Two Rivers Trail (Phase II) Environmental Impact Report – DEIR Appendices

Appendix A. IS/MND & Comments Received

A.1 Summary of Comments and Comment Letters

Two Rivers Trail Phase II: Written Comments regarding Initial Study/MND

Figure 1. Project Location Map

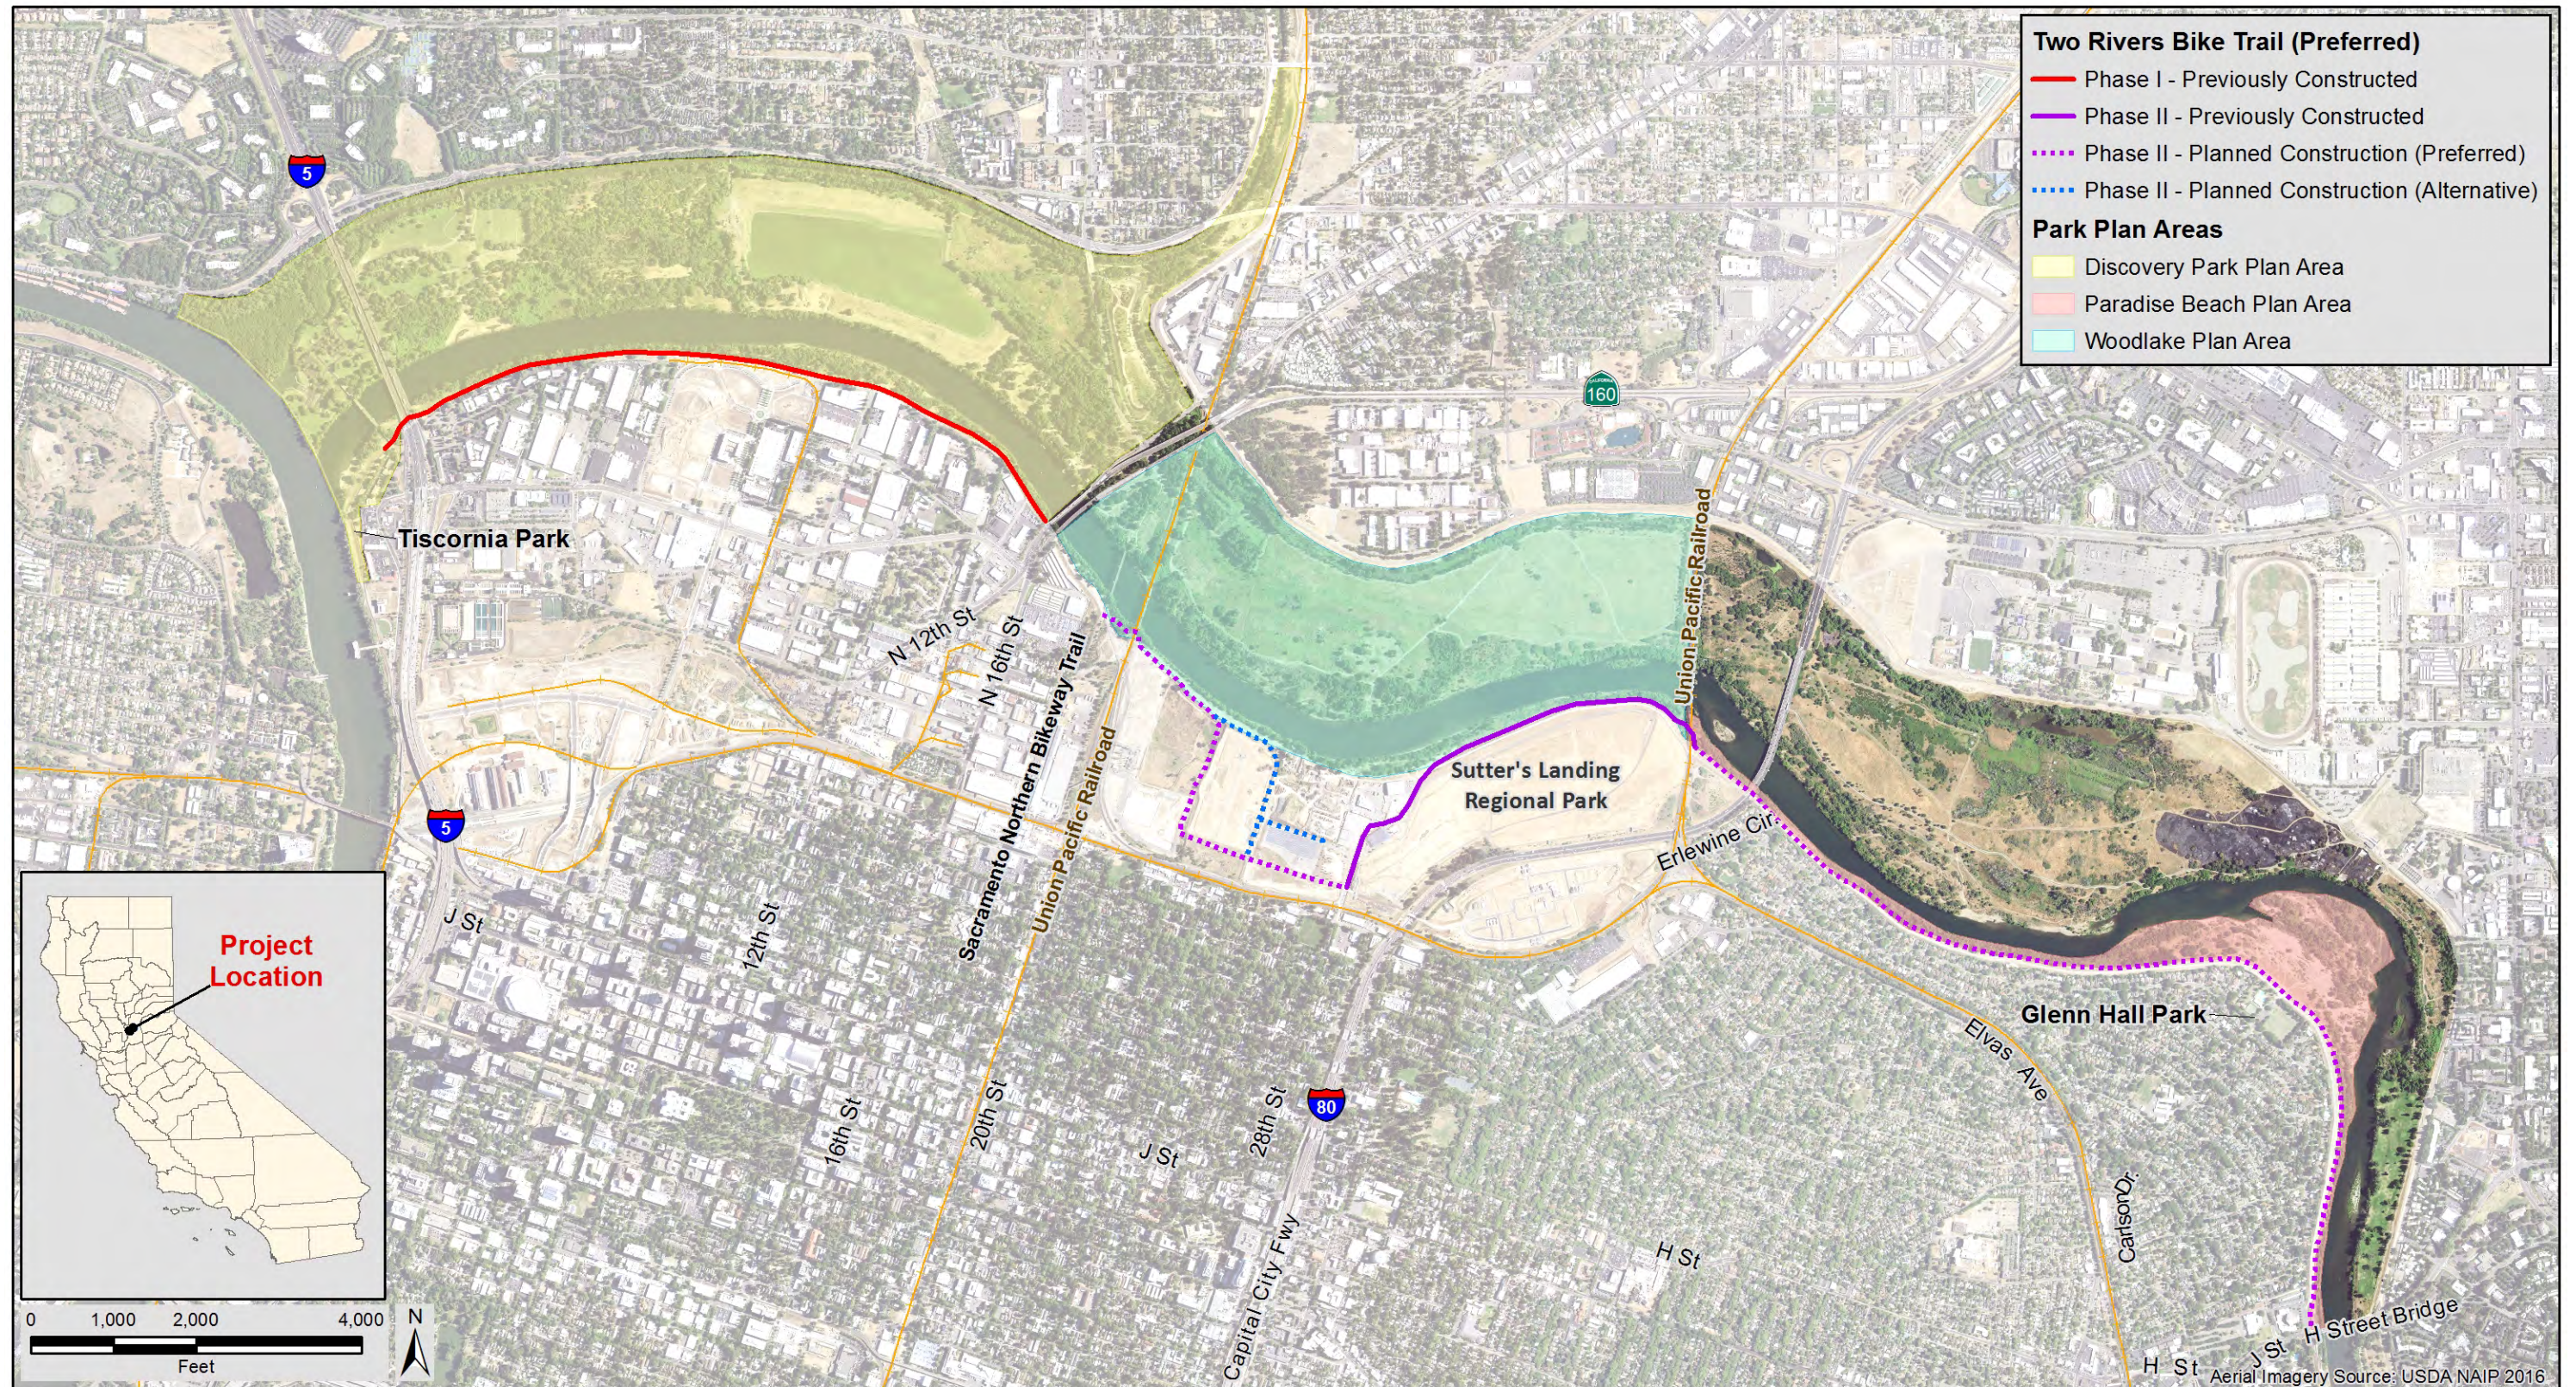
Figure 1 of the IS/MND shows the Previously Constructed portion of Phase II in Sutter's Landing. The route traced on the map follows the road (28th St) from McKinley Village Way to the skate park. The route on the map does not follow the expected, existing bike trail that runs behind the bocce courts and the solar-covered parking lot. Judging by this figure the project's intent is to "share the road", and abandon the alignment next to the landfill.

Figure 3. Proposed Trail Alignment – Eastern Segments

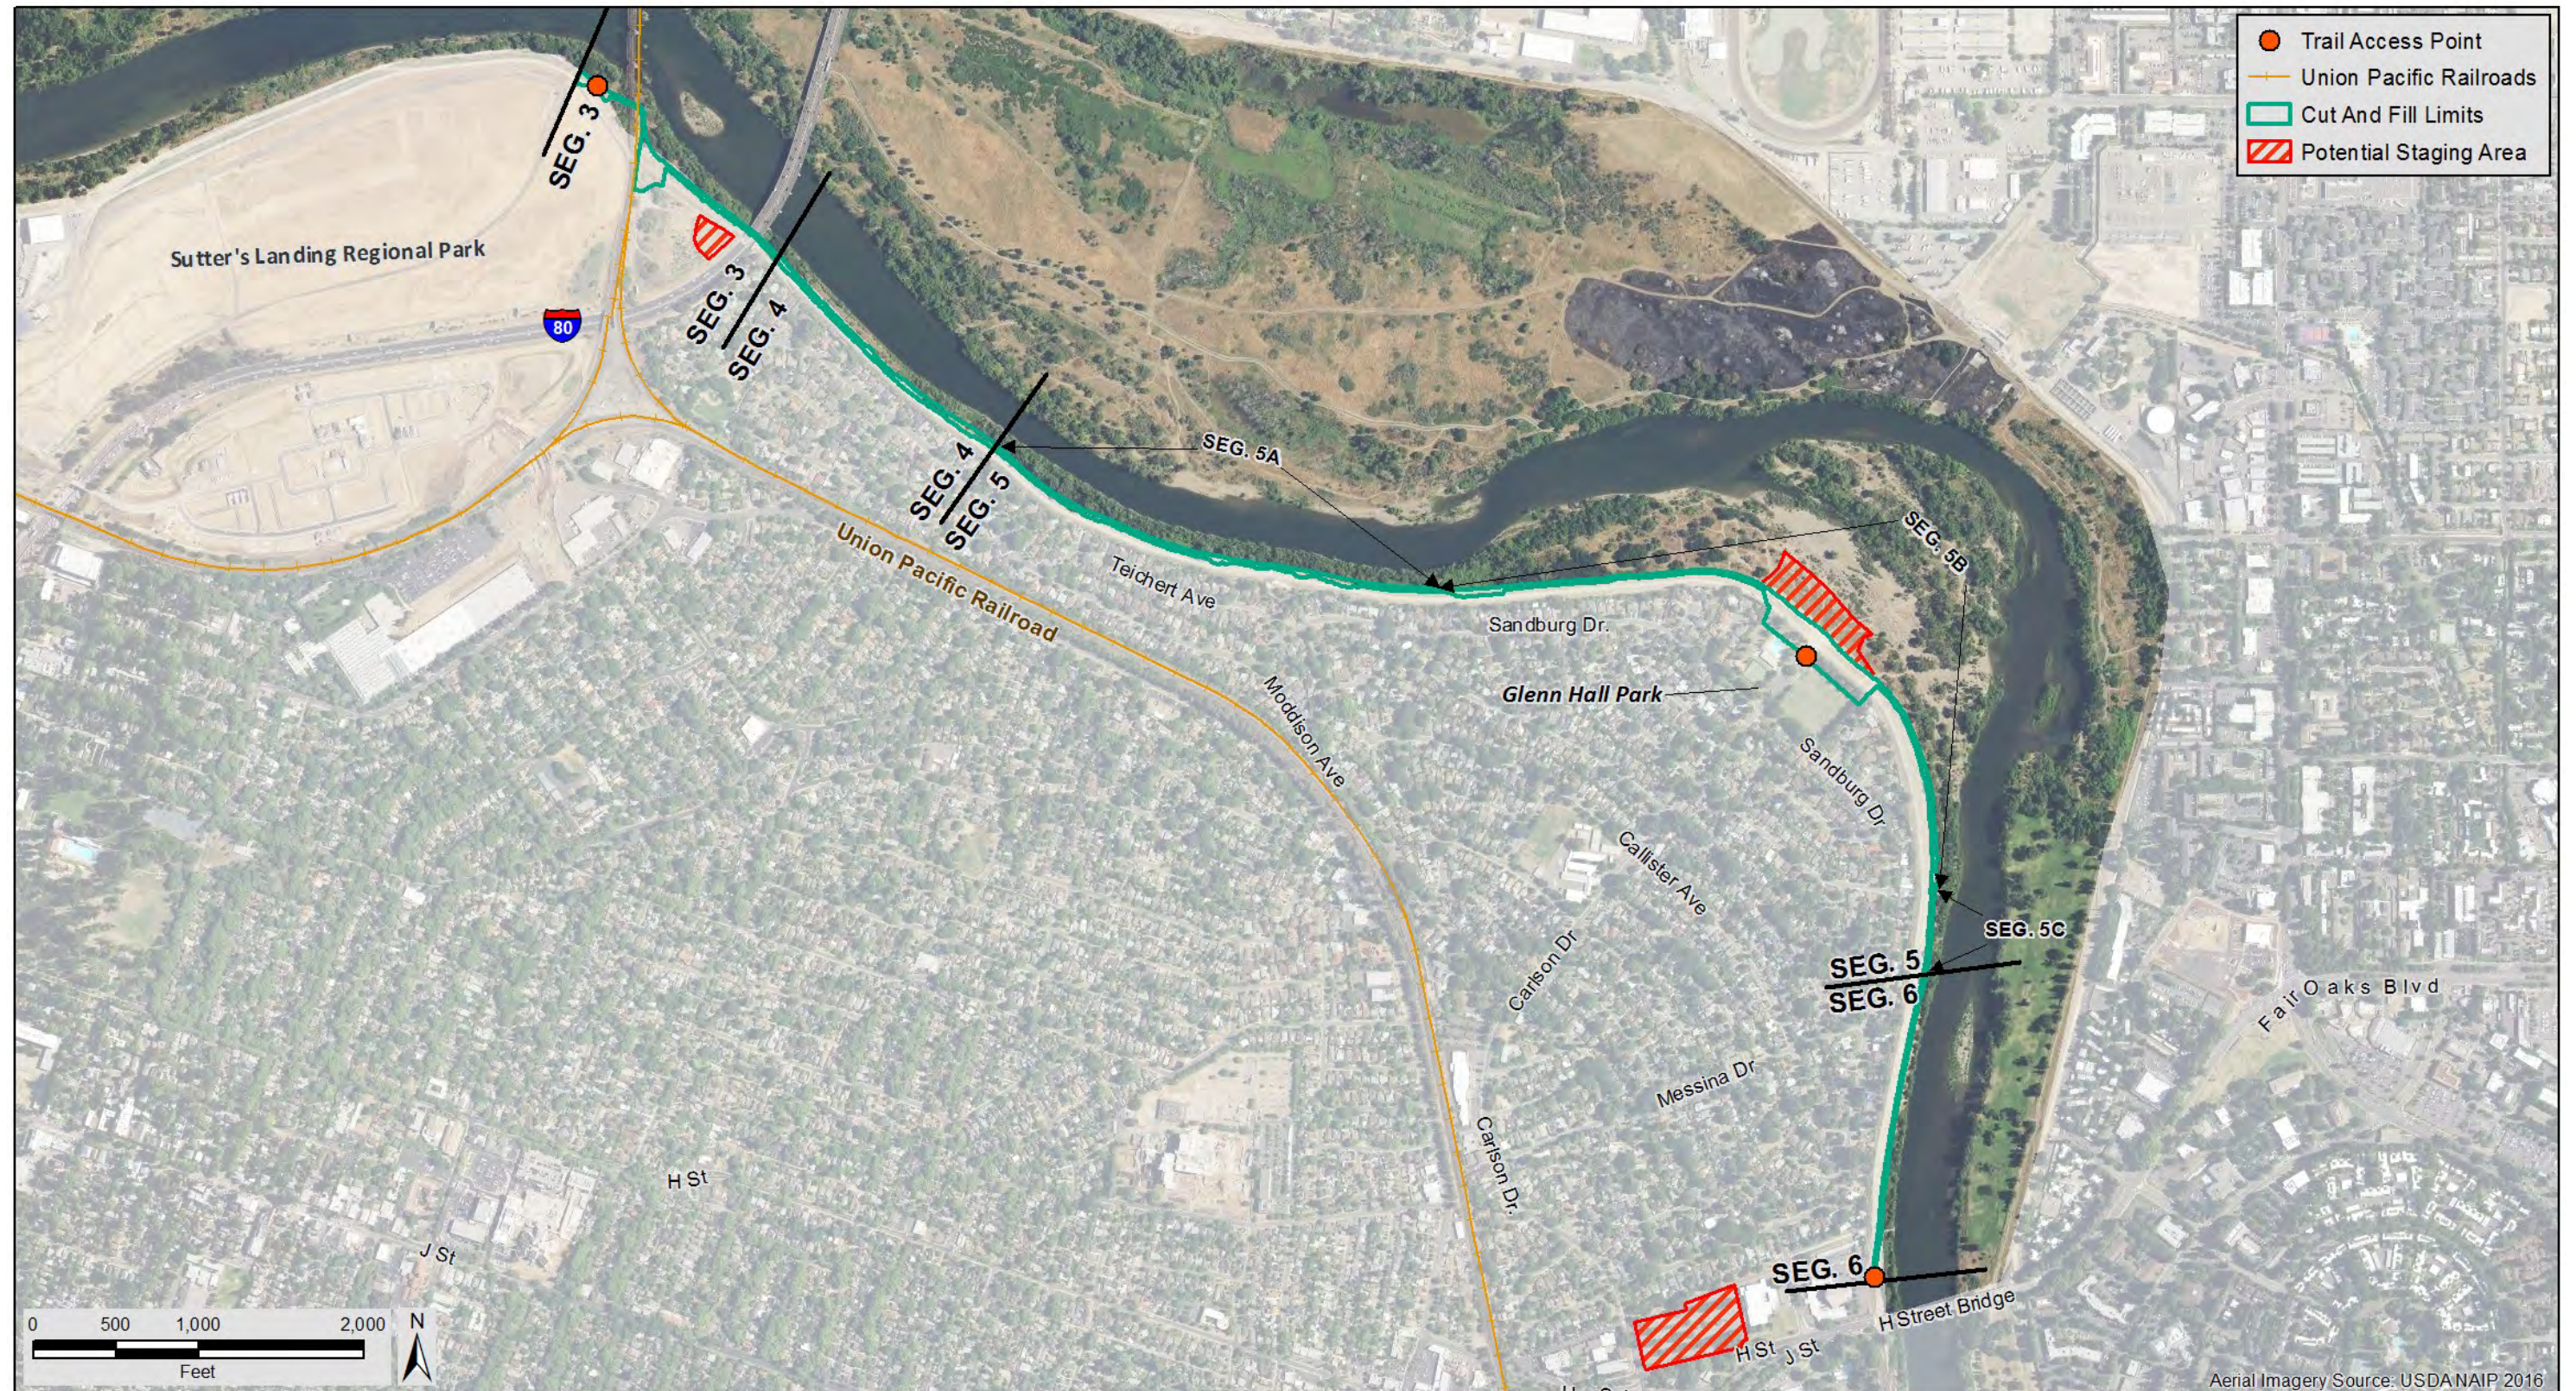
In order to help determine baseline use of the area of the area adjacent to the Glen Hall access to Paradise Beach (Segment 5; MND, Figure 3), Save Don’t Pave members collected data using volunteers starting on May 29, 2018 and ending on August 17, 2018. This data is compiled in Exhibit C, Baseline Recreational Use Data. To prepare for data collection, volunteers were provided with on site training regarding the different categories of data being collected and the optimal location for viewing use of Segment 5 of the Project area. Observation shifts lasted for no more than two hours. Shifts were scheduled to cover all daylight hours for one weekday and one weekend day, however they were not completed all on one day, but rather staggered over a few months as volunteer time allowed. Data was collected over a total of 8 weekday shifts, covering the hours from 5:30 a.m. to 9 p.m., and a total of 7 weekend day shifts, covering the hours from 5:30 a.m. to 7:30 p.m. Volunteers were set up facing the levee, and were instructed to categorize users as either: (1) primarily using the top of the levee; (2) primarily using the bottom of the levee; or (3) cross traffic (crossing the bottom of the levee to access the river area). Individual user types were categorized as Adult Pedestrians, Pedestrians appearing to be under 12 years old, Dogs, Runners/Joggers, Bikers, or Other. Survey results are compiled in Exhibit C, Baseline Recreational Use Data.

The subject IS/MND shows areas of permanent impacts (pages C-6 and C-7) and cut and fill limits (Figure 3, page 12). At the Fall RPNA meeting (October 6, 2018), the city provided an update on the project. The city's presentation included an alternative access design at Glen Hall Park. The original proposal would have constructed a paved ADA trail with switchbacks in the area behind the soccer/baseball field and possibly require removal of the row of conifer trees on the levee. The alternative design would be located behind the swimming pool, would require the removal of fewer trees at the south side of the levee, would have less visual impact and would cause less interference with athletic/recreational activity at the baseball /soccer field. The IS/MND does not show or discuss these two design alternatives.
